Project	<b>IEEE 802.16 Broadband Wireless Access Working Group</b> < <a href="http://ieee802.org/16">http://ieee802.org/16</a> >	
Title	<b>Block Turbo Code section edits in response to comment #524</b>	
Date Submitted	<b>2000-11-09</b>	
Source(s)	Dave Williams AHA 2365 NE Hopkins Ct. Pullman, WA 99163	Voice: 509 334 1000 Fax: 509 334 9000 <a href="mailto:davew@aha.com">mailto:davew@aha.com</a>
Re:	IEEE 802.16.1-00/01/r4	
Abstract	Clarifies shortening for both downstream Mode B and upstream. Replaces the 392-byte mode B down stream code with a 231-byte code due to TC layer limitations identified. Adds a method to shorten the last code word in a message.	
Purpose	In response to comment #524 calling for a clarification of the shortening method for BTCs. This change also addresses last code word shortening. The change also fixes a TC layer related problem with maximum code word sizes.	
Notice	This document has been prepared to assist IEEE 802.16. It is offered as a basis for discussion and is not binding on the contributing individual(s) or organization(s). The material in this document is subject to change in form and content after further study. The contributor(s) reserve(s) the righ

Fig. 5 Structure of Shortened 2 D Block

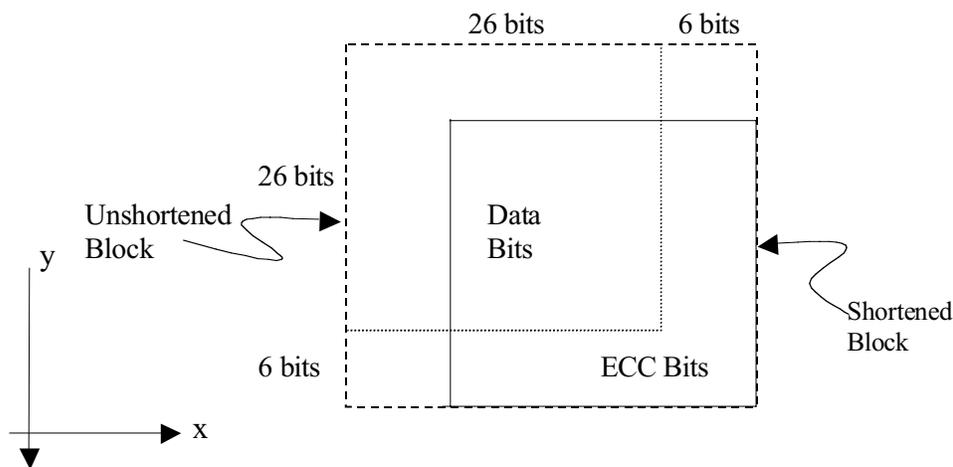
*In the upstream section (~page303 ln 62), replace text and figures with the following:*

For example, the 57 byte BTC code in the upstream is composed of (32,26) constituent codes in the two dimensional array which has been shortened by seven rows and two columns to form a (30,24) x (25,19) array. This code block has  $24 \times 19 = 456$  data bits, which is exactly 57 bytes. Fig. 5 shows the structure of the resultant block.

Modifications to the encoder to support shortening are minimal. Since shortened bits are always zero, and zeros input to the encoder LFSR result in a zero state, the shortened bits can simply be ignored for the purposes of encoding. The encoder simply needs to know how many bits per row to input to the row LFSR before shifting out the result. This also applies to the first row that has additional shortened bits. Similarly, it must know the number of columns to input to the column encoders.

Transmission of the resultant code block must start with the first data bit in the first row, proceed left to right and then row by row from top to bottom.
